CALIFORNIA COASTAL COMMISSION

Subject: STAFF REPORT ADDENDUM for Item 13a Consistency Determination (CD-001-12, U.S. Army Corps of Engineers, San Diego Bay Main Channel Deepening Project)

Consistency Determination No.	CD-001-12
Staff:	MPD-SF
File Date:	10/13/11
60th Day:	12/12/11
75th Day:	12/27/11
Extended to:	3/10/12
Commission Meeting:	3/9/12

The following comments are in response to statements contained in the referenced 2011 US Army Corps of Engineers consistency determination. These comments are being submitted on behalf of homeowners SLPR, LLC, Ann Goodfellow as Trustee of the Survivors' Trust Under the Goodfellow Family Trust, and Jerry Cannon and Michael Morris as Co-trustees of the Sewall Family Trust of 1985. The comments are based upon my review of the above referenced documents, site inspections, bathymetric survey comparisons, and general knowledge of coastal processes. The following comments add to my comments referenced above, which were submitted in response to the draft SEIS. I have over 30 years of experience as a coastal engineer. My CV is enclosed with this letter.

Figure 2. The 1902 Navigation Chart in fathoms overlain with the 2008 Port of San Diego bathymetric survey, in feet below MLLW, denoted in red. The Coronado streets are First Street property address are marked.

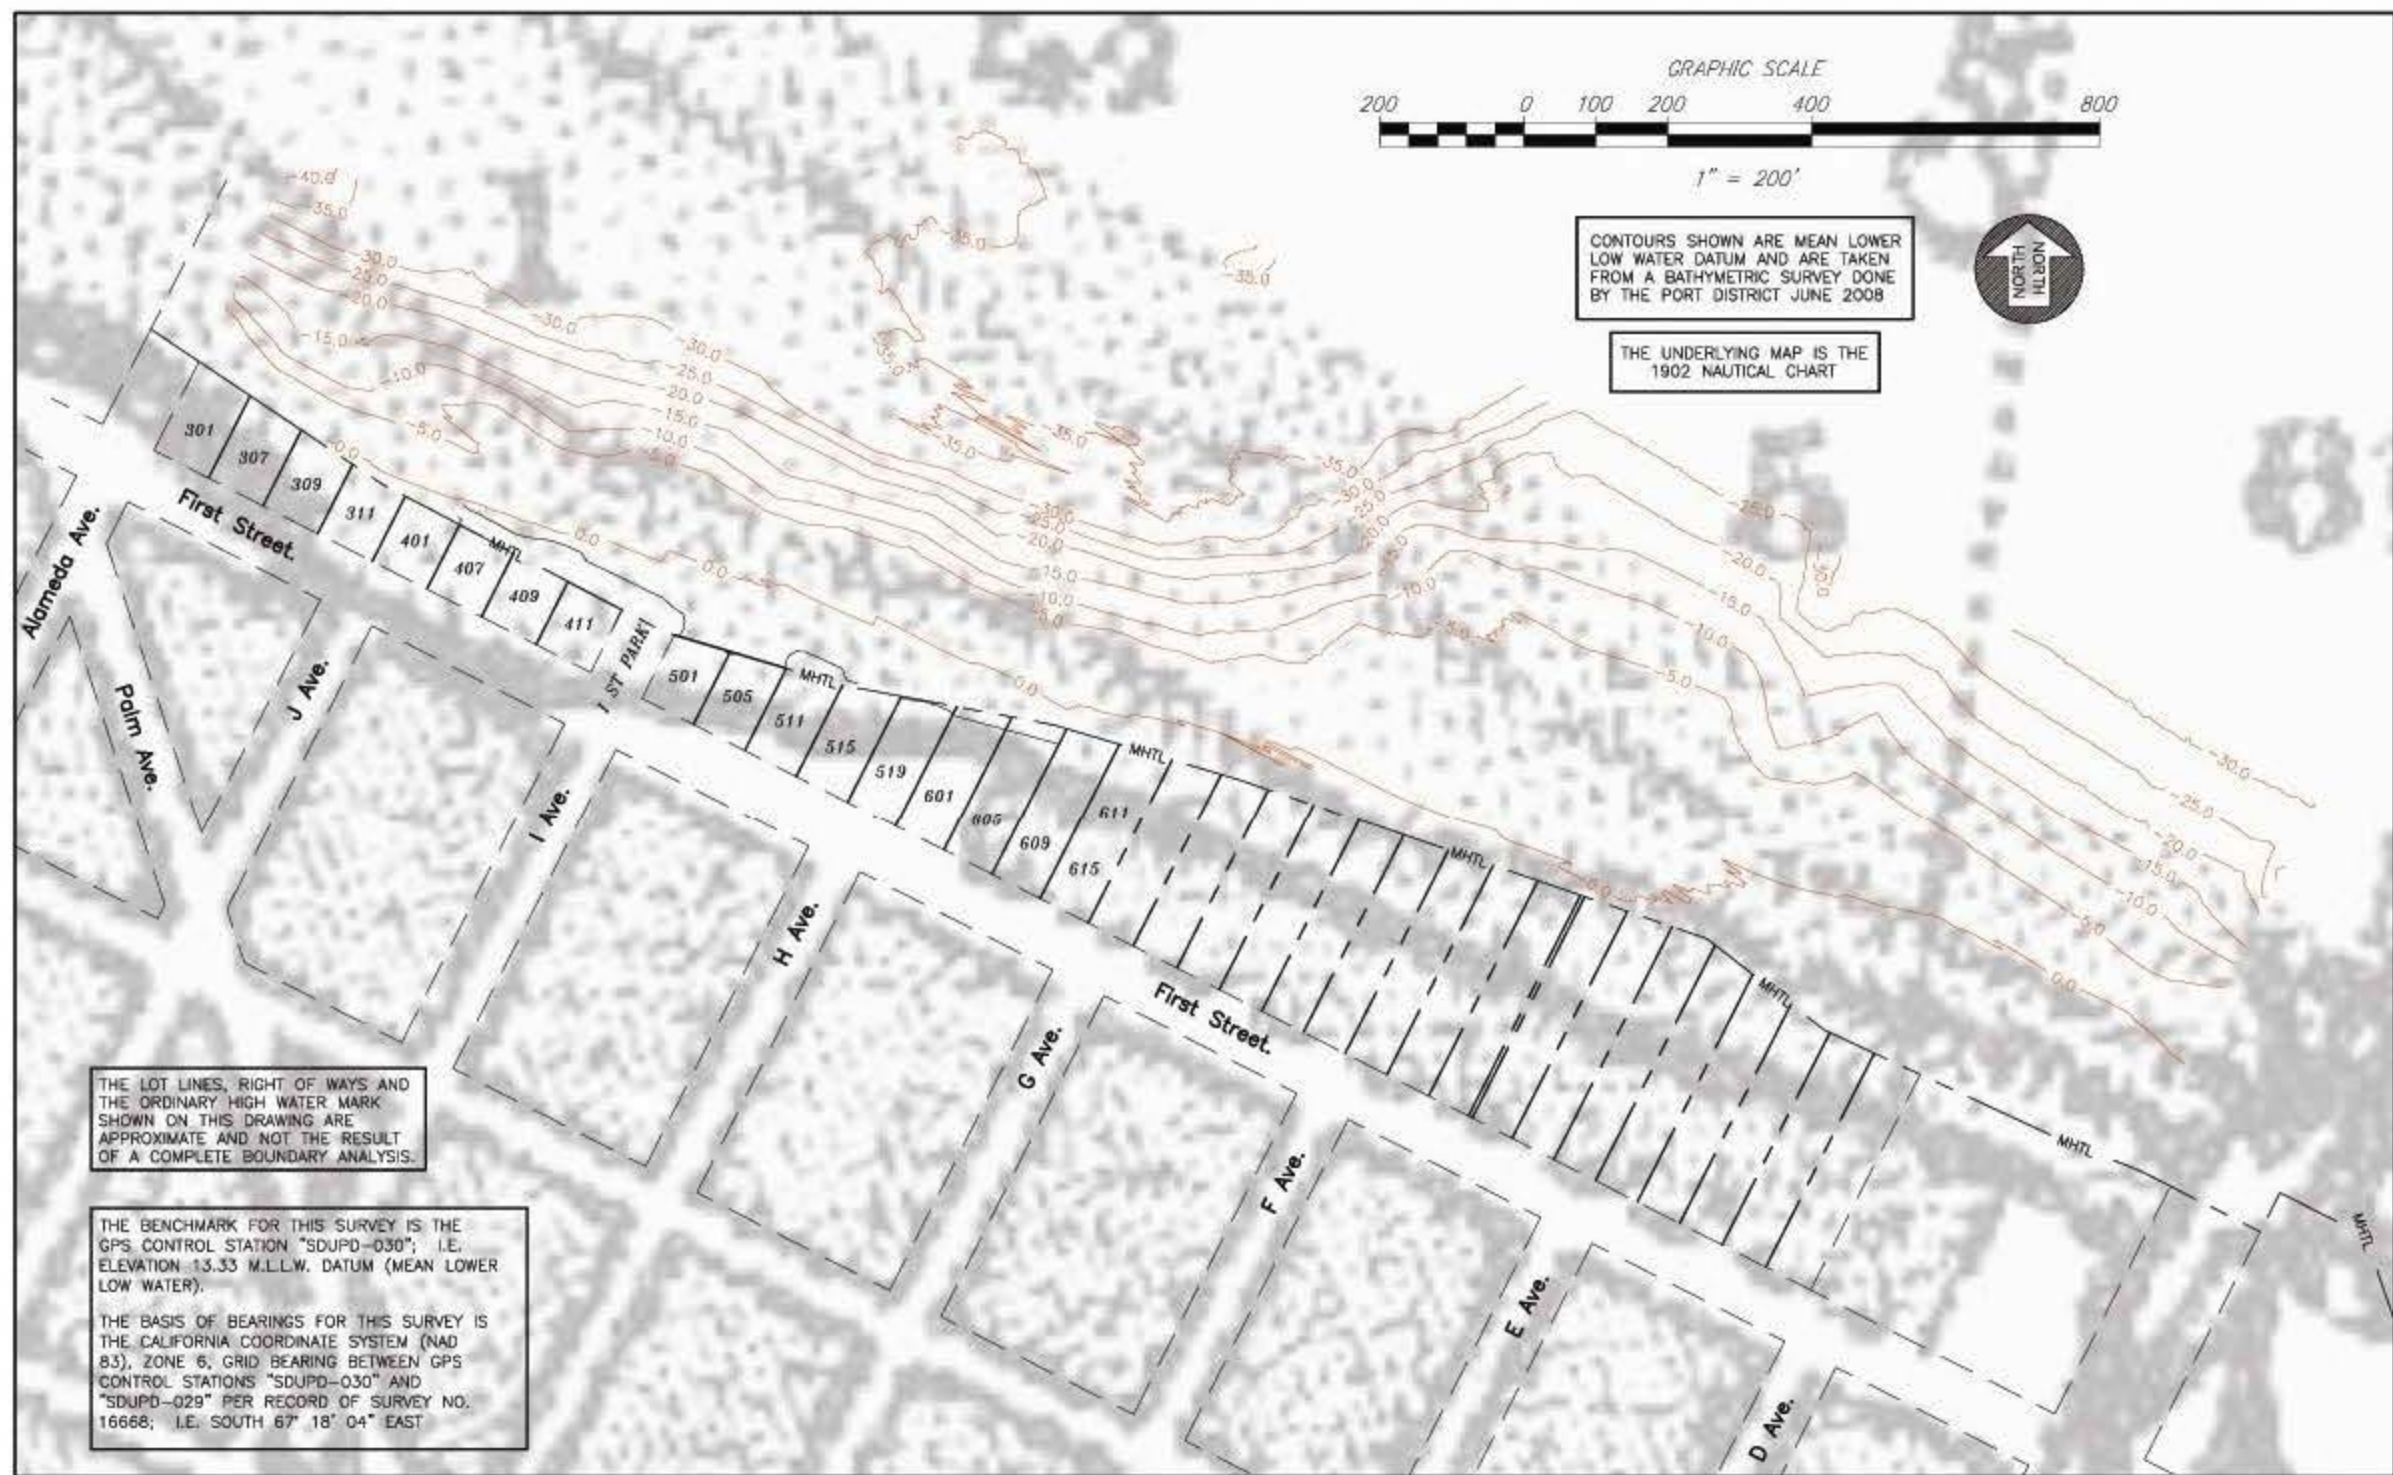
1. Comparing 2008 to 1902 underwater contours off Coronado to recent contours, depth contours have moved landward "as much as 400 ft." and in some areas, are nearly perpendicular to the shoreline, whereas they were roughly parallel to the shoreline in 1902 (see Figure 2 of Mr. Skelly's letter (copy attached)). "The modification of the depth contours was the result of dredging within San Diego Bay. It is very clear that over time dredging of the bay has resulted in the steepening of the depth contours in the vicinity of First Street."

The Commission staff does not believe any of the points made in Mr. Skelly’s letter can be considered evidence that the two foot deepening of the Main Channel reviewed in the subject consistency determination has accelerated erosion along First St. The Commission’s staff engineer and geologist have reviewed this additional material and also agree that the conclusions contained in the recommended findings, which are that “No evidence has been presented establishing that shoreline erosion has accelerated since the implementation of the channel deepening in 2004/2005, or that ship traffic has increased,” remain valid. The differences shown in the 309 First St. profile are statistically meaningless; the 1999 and 2008 profiles are nearly identical. The Commission staff does not disagree that there has been erosion of the First St. shoreline; the staff report explains why, due to historical fill and cessation of sediment inputs, as well as the above-acknowledged shoreline protection devices lining the bay side of the First St. properties, such erosion is inevitable. As the staff report states:

CORONADO-309 FIRST ST.- SAN DIEGO BAY PROFILES

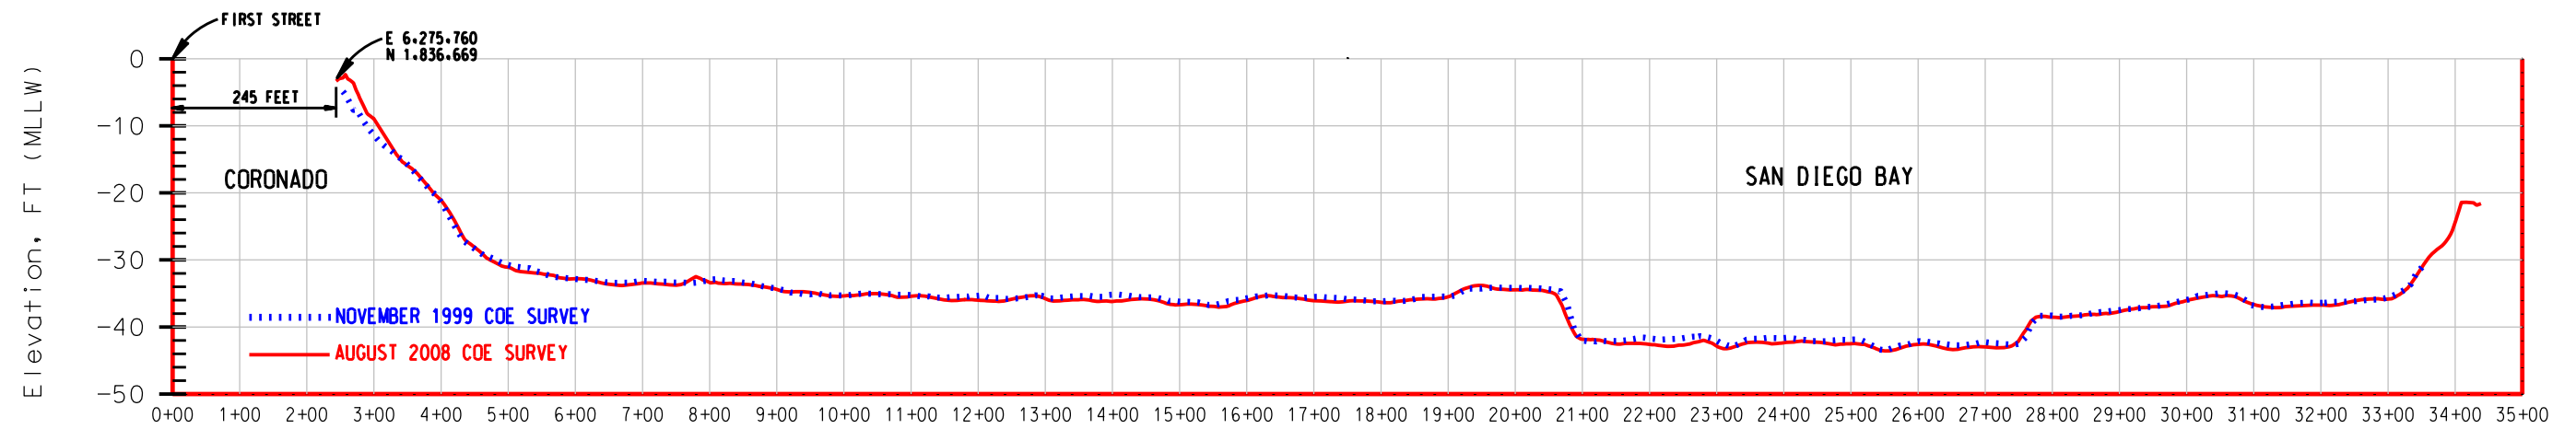
- (b) comparing the enlarged 309 and 407 First St. profiles shows that at 245 ft. from First St., water profile elevations are 10 ft. deeper in front of 311 First St. as compared to 407 First St., indicating a steepened gradient; and

- (c) some erosion has occurred at 309 First St. near the shoreline and at -28 ft. MLLW, and some steepening of the profile has occurred between horizontal stations 3+00 and 4+00.

Figure 1. 1902 Navigation Chart of San Diego Bay. The depth is in fathoms (1 fathom = 6 feet).

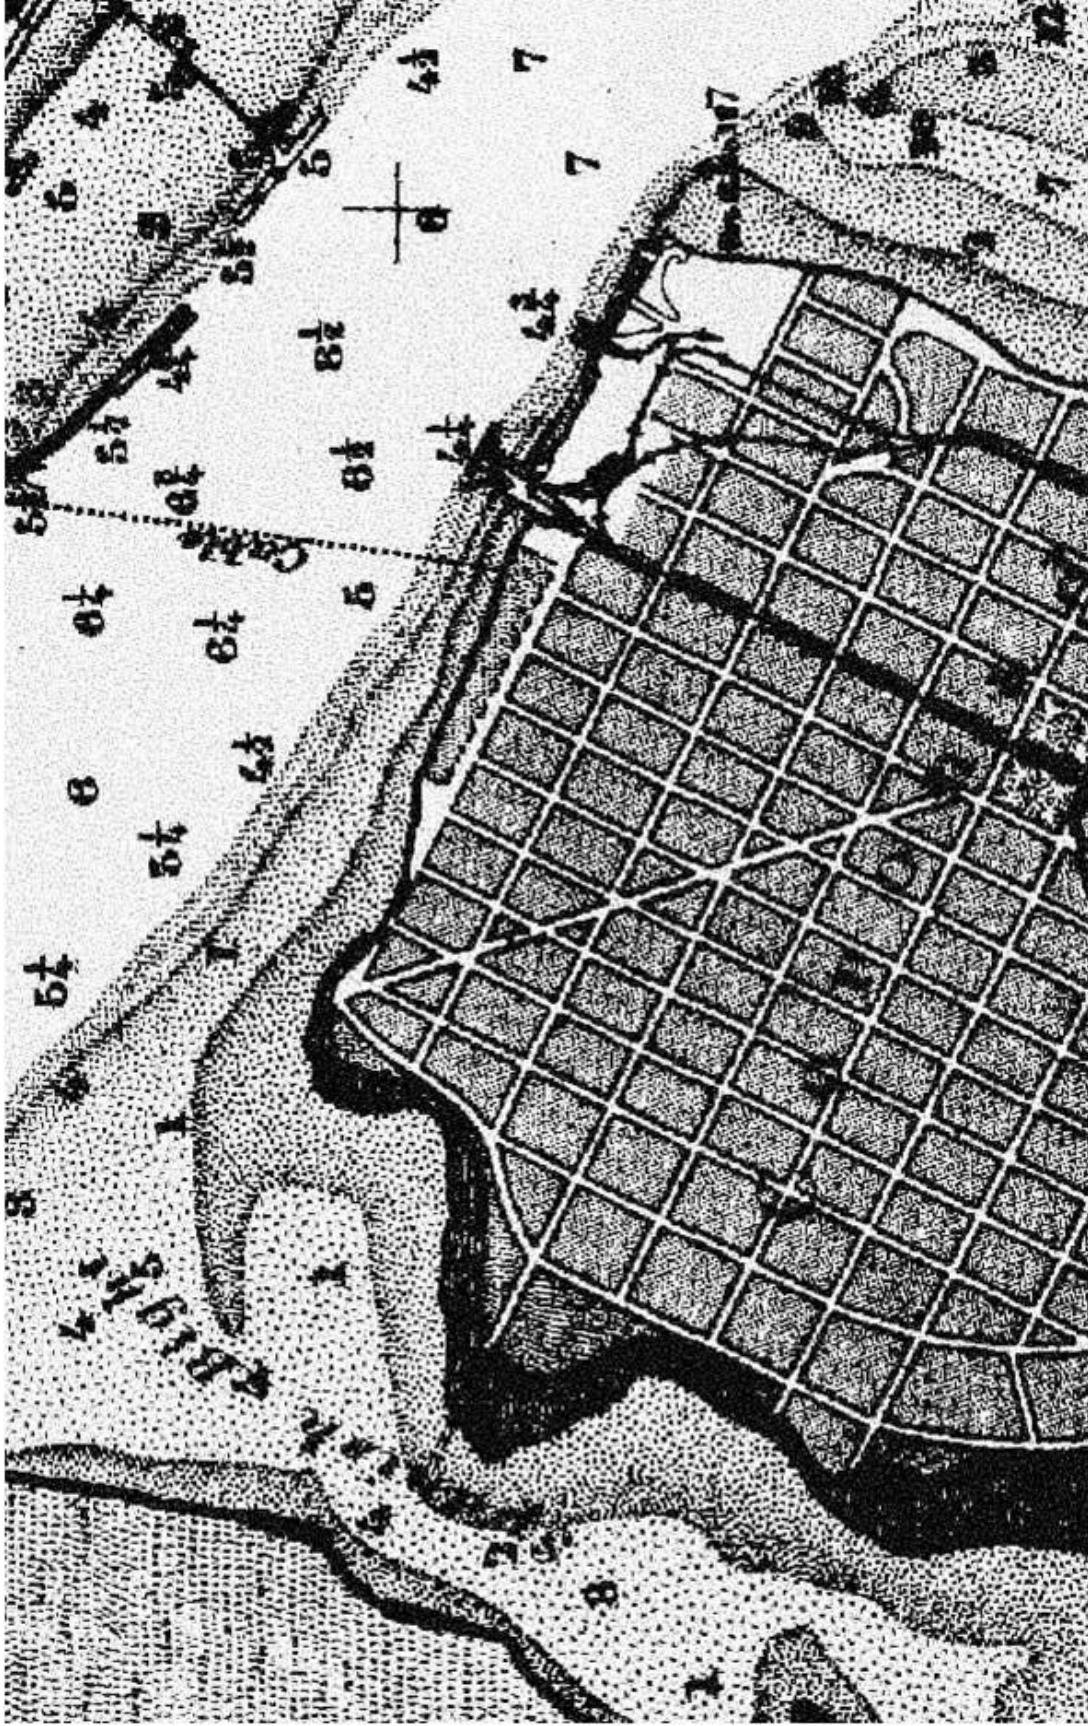
Figure 1 enclosed with this letter shows the 1902 nautical chart of the area in front of First Street. The depth contours, shown here in fathoms (1 fathom = 6 feet), are relatively parallel to the shoreline. There is a broad terrace feature fronting First Street, particularly in front of the 300 to 500 block of First Street that extends from the shoreline
